Technical Memorandum

Update to Frequency of Storage at the Chain of Lakes

Date: March 9, 2006

DRAFT Technical Memorandum

Figure 3 Updated Schematic of Proposed Diversion Flows during a 100-Year Event

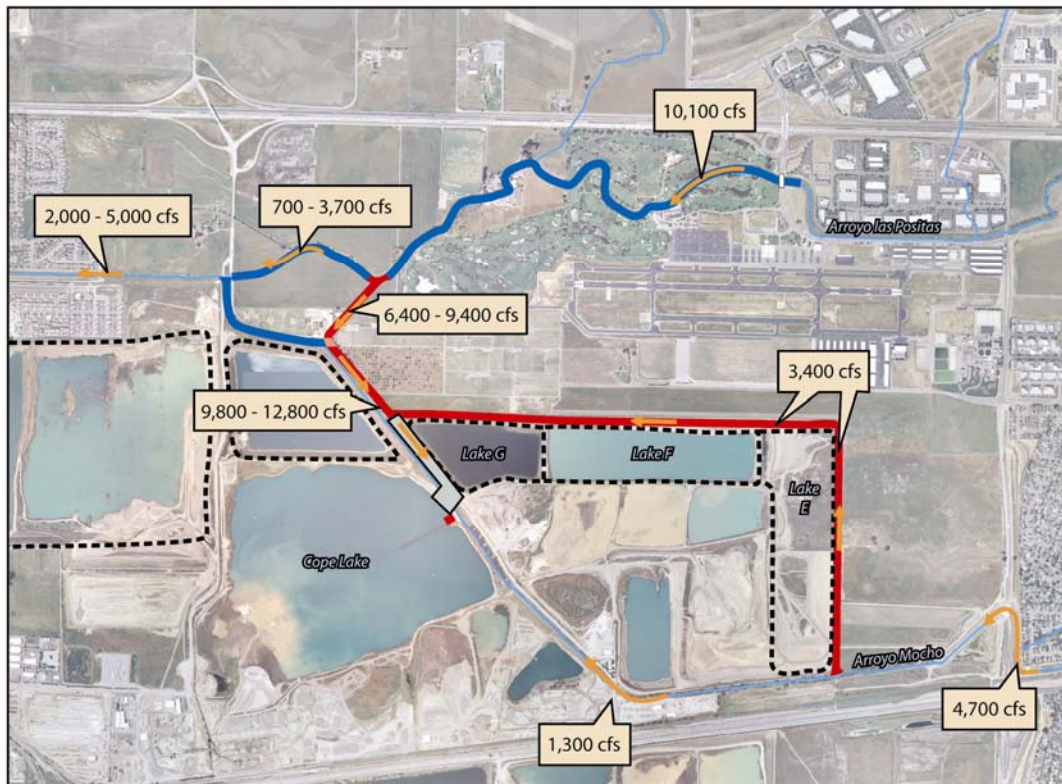
The previous schematic of proposed stormwater diversion flows during a 100-year event (Figure 3) is updated as shown below. Updates in flows are based on refinements to Chain of Lakes project components resulting from further conceptual design.

As previously discussed in the Draft Frequency of Storage TM, it is anticipated that 3,400 cubic feet per second (cfs) of the 4,700 cfs peak flow in Arroyo Mocho will be diverted into the Arroyo Mocho Bypass Channel during a storage event. The peak flow on Arroyo las Positas is estimated to be 10,100 cfs, and an expected 6,400 to 9,400 cfs would be diverted to storage. These diversions during the future 100-year storm event will leave 700 to 3,700 cfs in Arroyo las Positas and 1,300 cfs in Arroyo Mocho. The expected flow in Arroyo Mocho (downstream of the confluence with Arroyo las Positas) when storage is triggered ranges from 2,000 to 5,000 cfs. The revised Figure 3 is shown below.

Figure 3 Schematic of proposed diversion flows during a 100-year flood

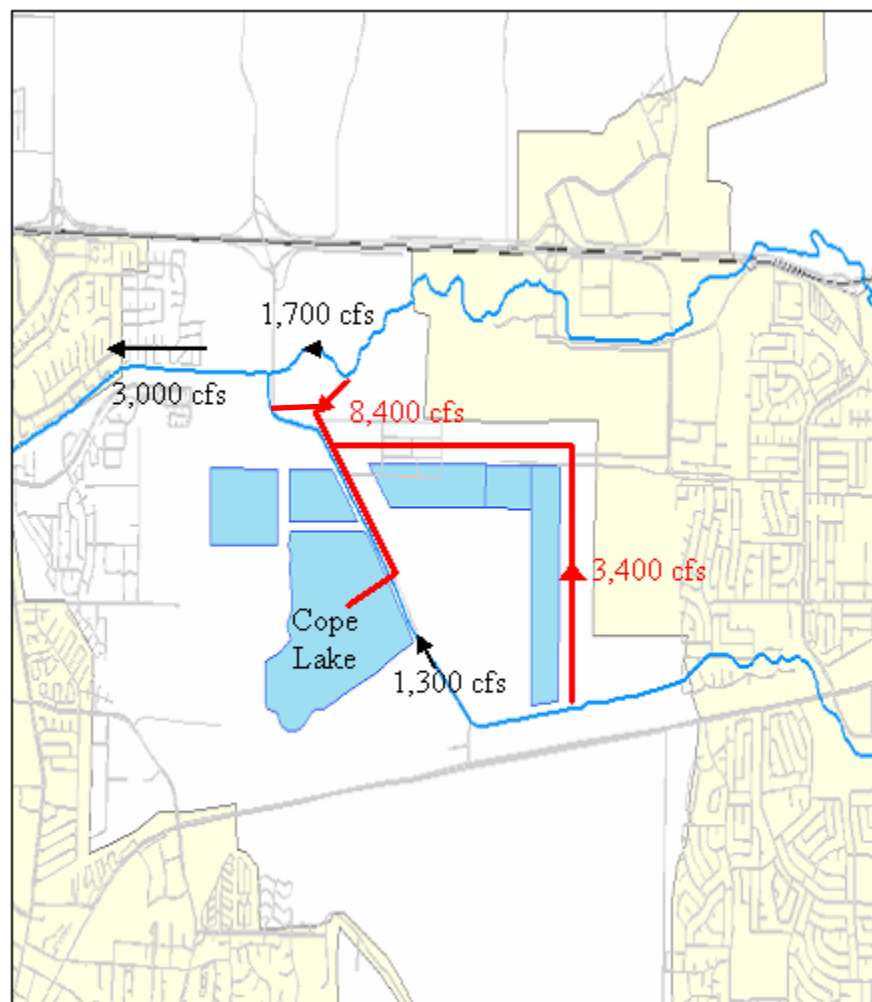
As seen in Table 3, approximately 5,200 AF of storage will be required to meet the 18,730 cfs capacity at ADLL during a 100-year flood². A schematic of the approximate stored flows and bypassed flows is shown in Figure 3.
